T-082 SERVICE BULLETIN

P/N(s): E6878498

Rework of E6878498 2nd Stage Nozzle

Engine Application(s):	Allison 250-C20, C20B, C20F, C20J, C20S, B17B, B17C, B17D, B17E
Subject:	Second Stage Turbine Nozzles – Modify for Incorporation of an Internal Energy Absorbing Ring.
Compliance:	Customer option.
Revisions:	N/C Dated: 6/16/04 Original issue. A Dated: 6/22/04 Corrected typographical error in Figure 1. B Dated: 8/13/09 Updated EXTEX to TIMKEN. C Dated: 2/05/16 Updated Timken to EXTEX Engineered Products.

FIGURE 1.

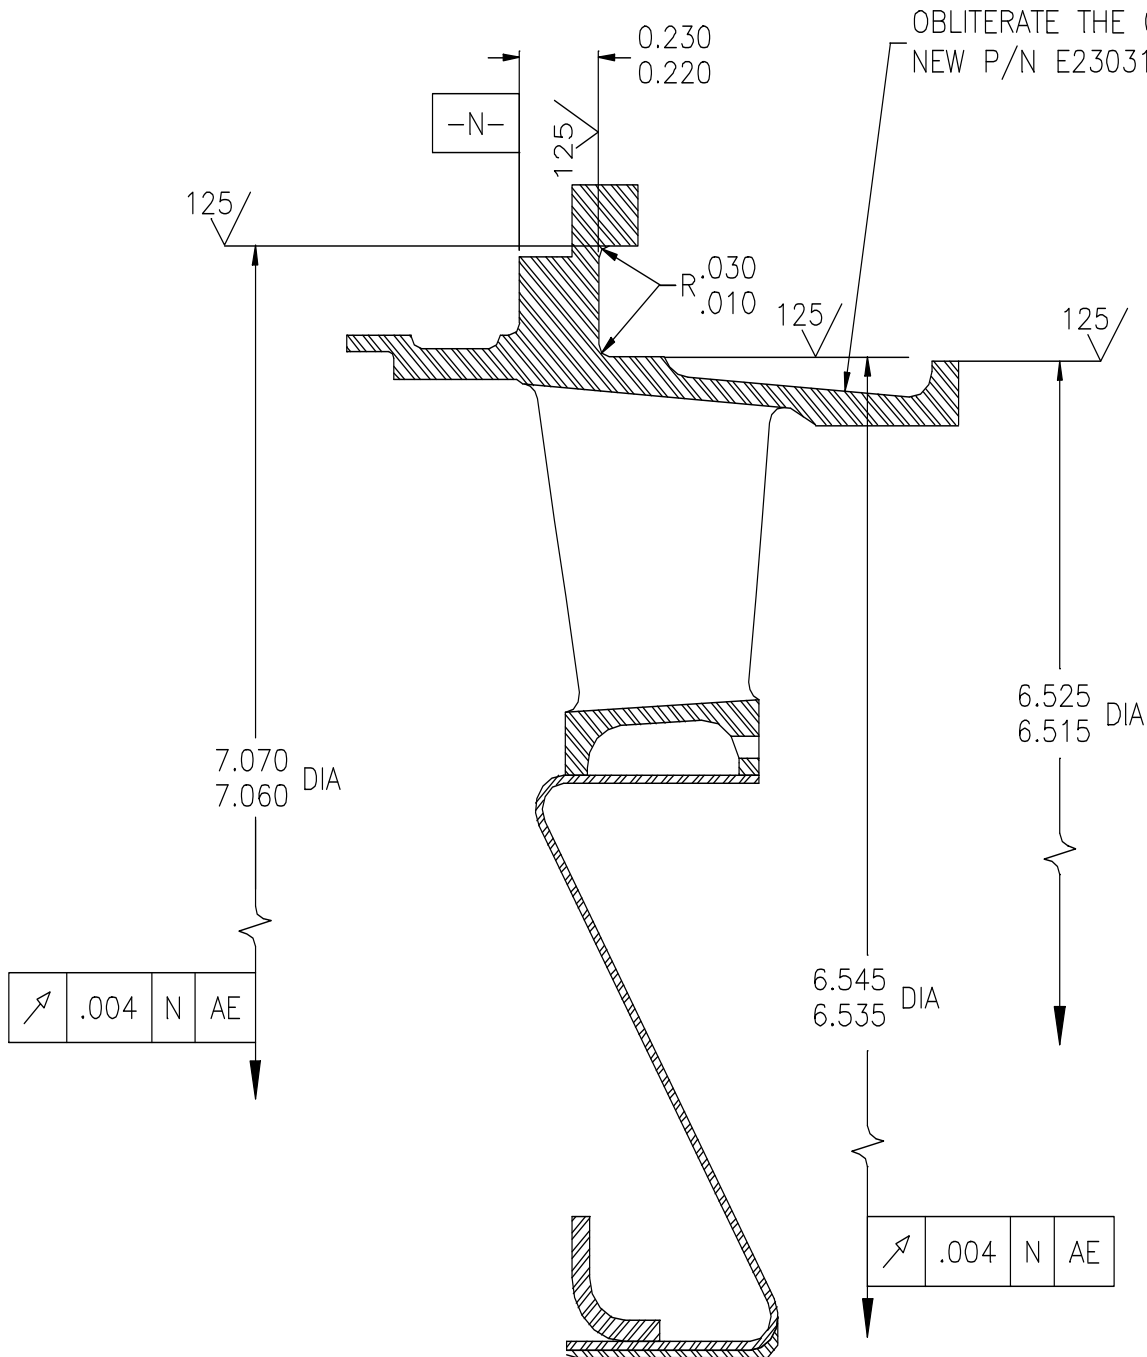
1. Rework Nozzle Assembly.
 - 1.1 No inspection or airflow adjustment is required when performing this work on a new nozzle. If nozzle has been in service, inspect per T-009.
 - 1.2 Machine a groove in the upstream (leading edge) face of the eight lugs on the outer band of the nozzle assembly (Ref. Fig. 1). (Ref. Dia. 7.070/7.060 inches and 6.545/6.535 inches).
 - 1.3 Machine the OD of the seal lip at the leading edge of the outer band to 6.525-6.515 inches.
 - 1.4 Obliterate old P/N E6878498 and re-identify as E23031938.

OBLITERATE THE OLD P/N AND MARK
NEW P/N E23031938 PER AS478-2D1.

DATUM AE IS FORMED BY 8 EQUALLY SPACED TANGS.
